# Product Change Notice (PCN)

PCN Number: **PCN-0451069R-01**

Product(s) Affected: PJ-018H-SMT-TR

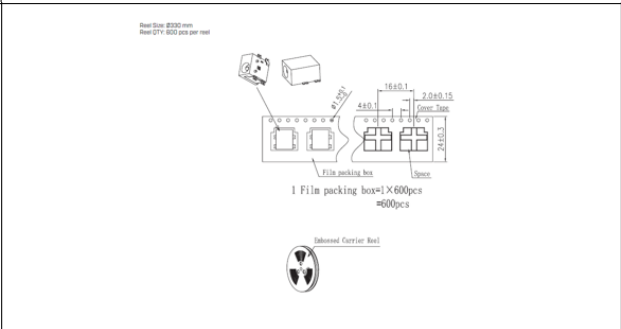
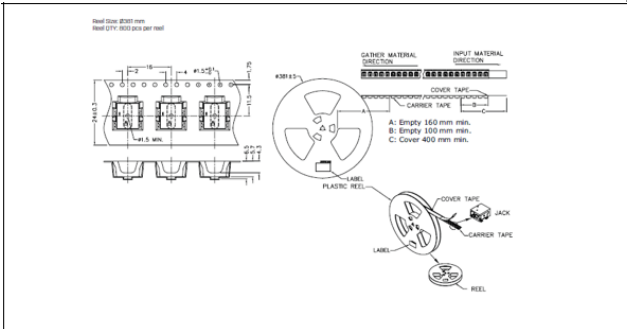
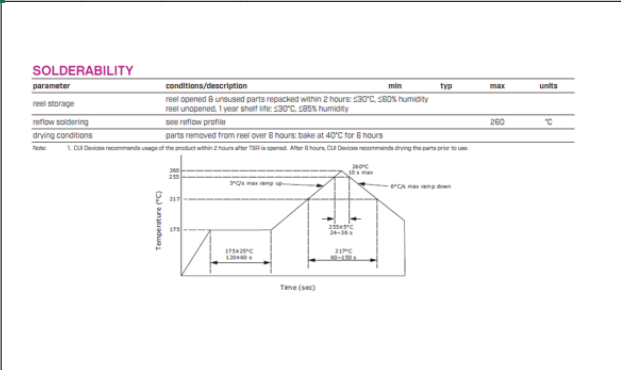
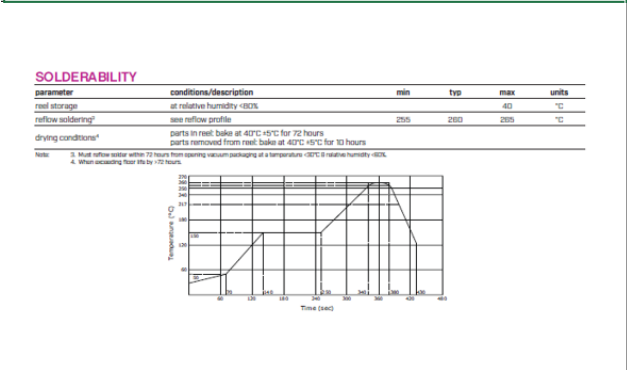
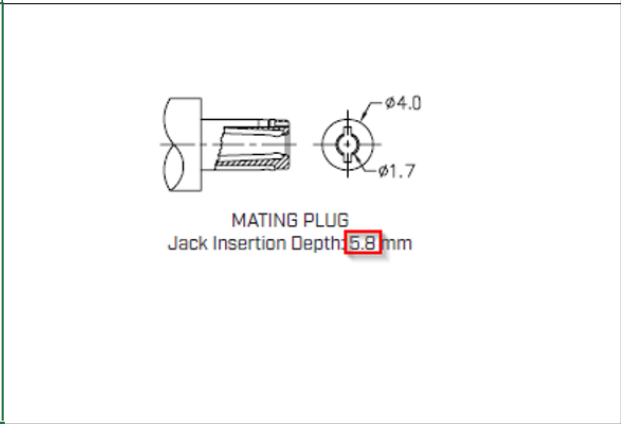
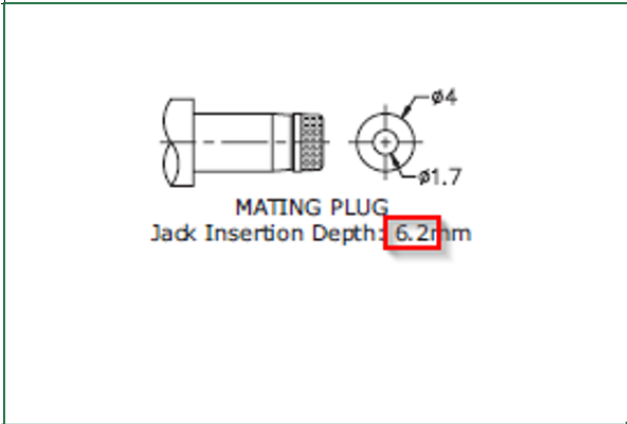
Description of Change: mechanical, material, packaging, and soldering differences as shown below:

MATERIAL	PLATING
center pin	copper	nickel
terminal 1	brass	silver
terminal 2	copper alloy	silver
terminal 3	brass	silver
plastic	PA6T or equivalent

DESCRIPTION	MATERIAL	PLATING/COLOR
center pin	H62	silver
terminal 1	brass t=0.30	silver
terminal 2	C5210R-EH t=0.20	silver
terminal 3	brass t=0.25	silver
housing	PA9T (UL94V-0)	black
